**Re: Replacement Plan for Well M57 and Testing Procedures for the Production Test Facility
UIC Permit No. R9UIC-AZ3-FY11-1
Florence Copper, Florence, Arizona**

Comments on the Florence Copper MIT and Well Construction and Abandonment Procedures
Submitted in January 2019

**M57-O WELL CONSTRUCTION
AND ABANDONMENT PROCEDURES**

**M57-O (R)
 SUPPLEMENTAL MONITORING
 PROPOSED WELL DESIGN**

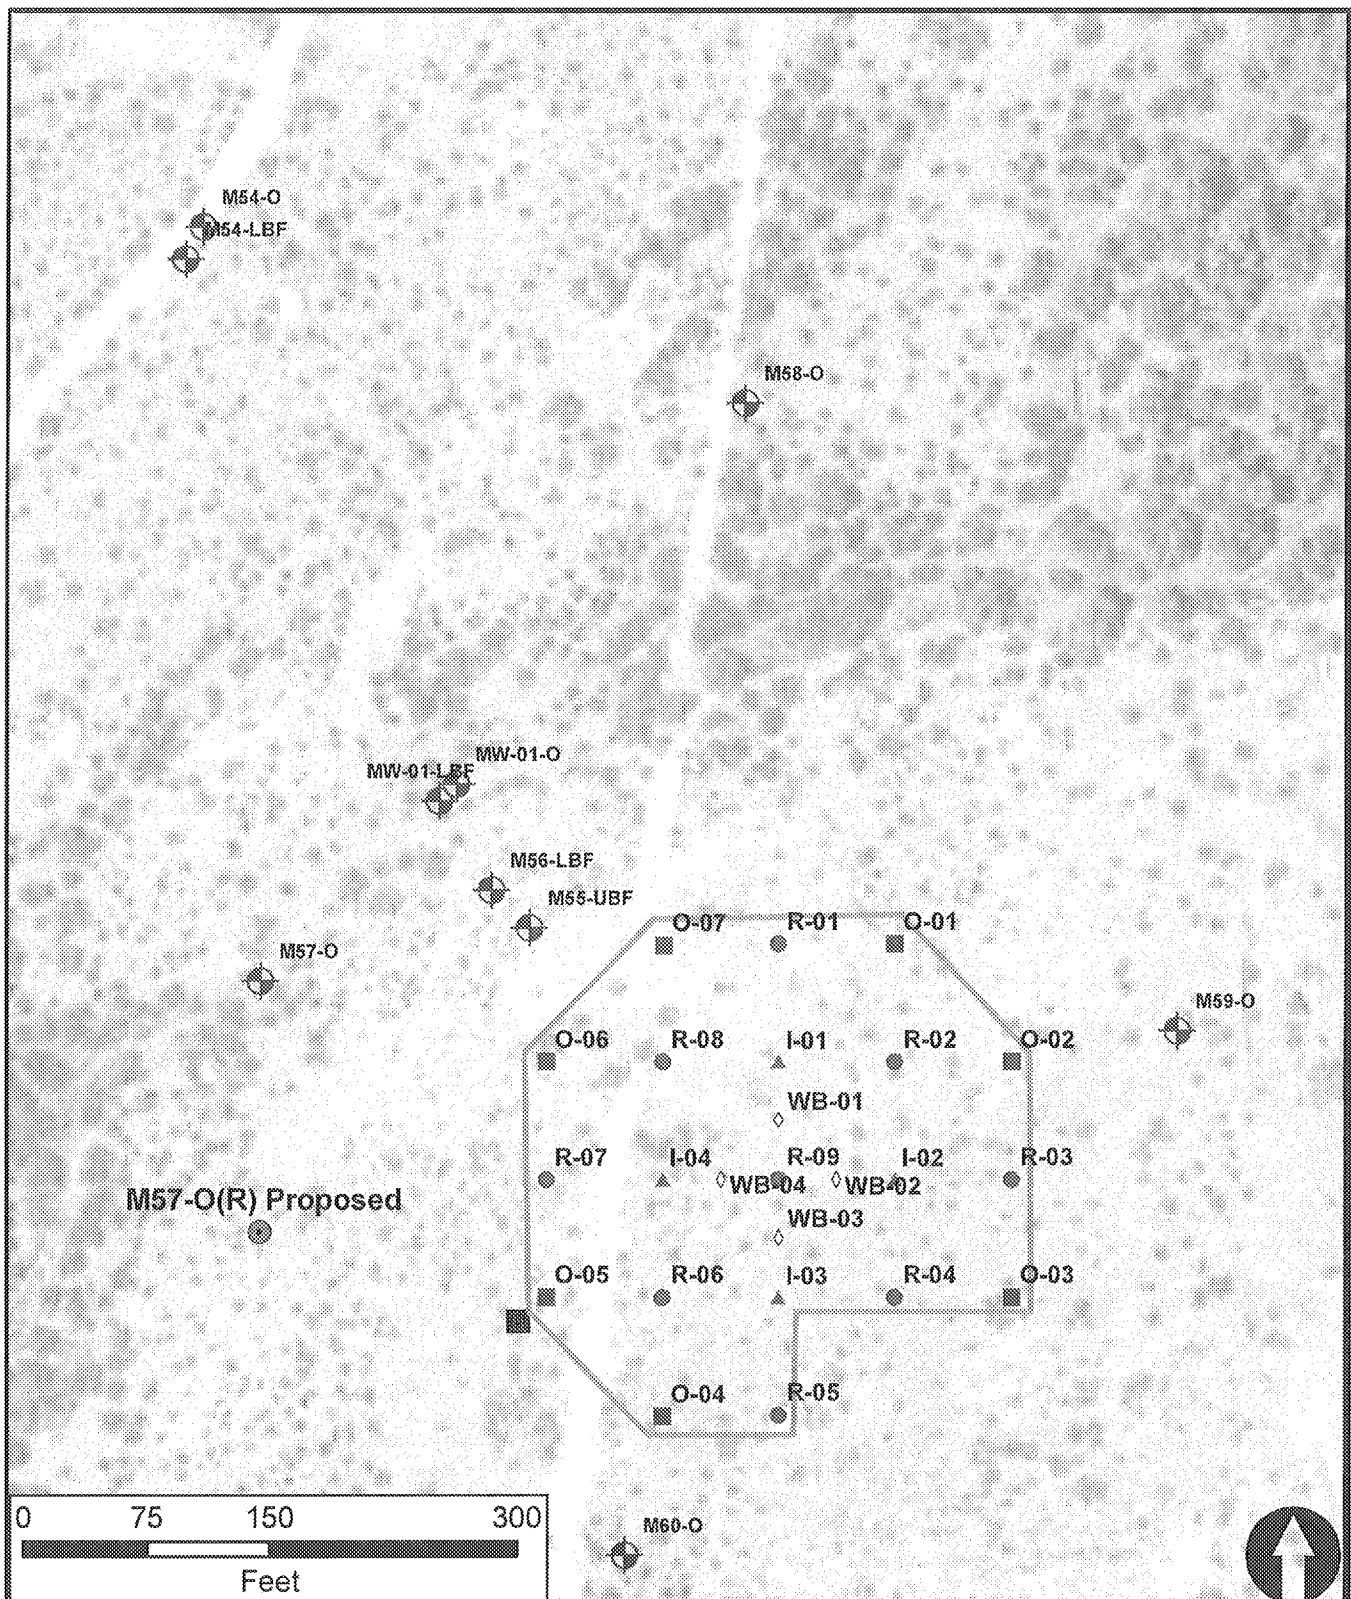
Casing centralizers will be installed and secured to the well casing and screen at 40-foot intervals, but are not shown in Figure A of Appendix A, as stated in Section 3.3. Figure A should be revised to show the centralizer locations on the casing and screen intervals.

Response: The well diagram included Attachment 1 and in Appendix C has been revised to show casing centralizers.

Casing centralizers will be secured to the well casing and screen at 40-foot intervals, as shown in Appendix A. The casing and screen will be hung in tension, centered in the borehole, until all annular material has been installed.
